**APPLICATION FOR PERMISSION
UNDER SECTION 16 OF
THE TOWN PLANNING ORDINANCE
(CAP. 131)**

For Official Use Only 請勿填寫此欄	Application No. 申請編號	A/YL-KTN/1258
	Date Received 收到日期	2026-07-08

(a) Full address / location / demarcation district and lot number (if applicable) 詳細地址/地點/丈量約份及地段號碼 (如適用)	Lot 1434 (Part) in D.D. 107, Kam Tin, Yuen Long, New Territories
(b) Site area and/or gross floor area involved 涉及的地盤面積及/或總樓面面積	☒ Site area 地盤面積 498 sq.m 平方米 ☒ About 約 ☒ Gross floor area 總樓面面積 379 sq.m 平方米 ☒ About 約
(c) Area of Government land included (if any) 所包括的政府土地面積 (倘有)	 N/A sq.m 平方米 ☐ About 約

(S.16 Planning Application No. A/YL-KTN/1258)

FIRE SERVICE INSTALLATIONS

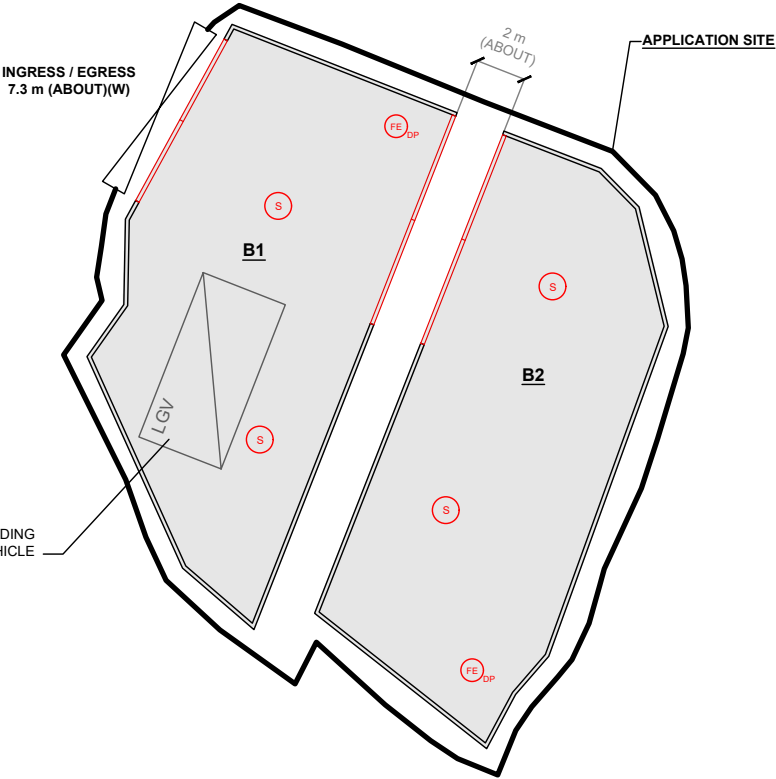
2. Comments of the Director of Fire Services (D of FS)		
(a)	A sufficient number of stand-alone fire detectors shall be provided at Structures B1 & B2.	Noted and revised accordingly. Please refer to the revised fire service installations proposal (Annex I).

EXISTING FILLING OF LAND AND POND TO BE REGULARISED

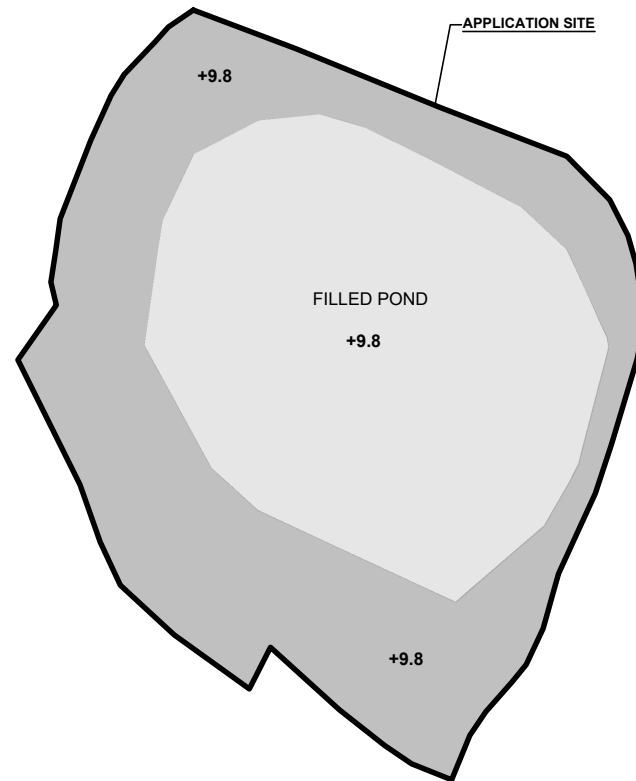
3. Comments of the Chief Building Surveyor/New Territories West, Building Department (CBS/NTW, BD)		
(a)	The 7m high structures are considered excessive. It should be justified upon formal plan submission to BD.	The Site is the subject of a previous application No. A/YL-KTN/979 for the same ‘warehouse’ use, which was approved by the Board on a temporary basis of 3 years in July 2024. Comparing with the previous application, all development parameters, including but not limited to the building height (i.e. 7 m), remain unchanged.

(ii) The applicant provides a revised plan showing the filling of land and pond at the application site. In addition, the revised application form and supplementary statement are enclosed at **Annex II**.
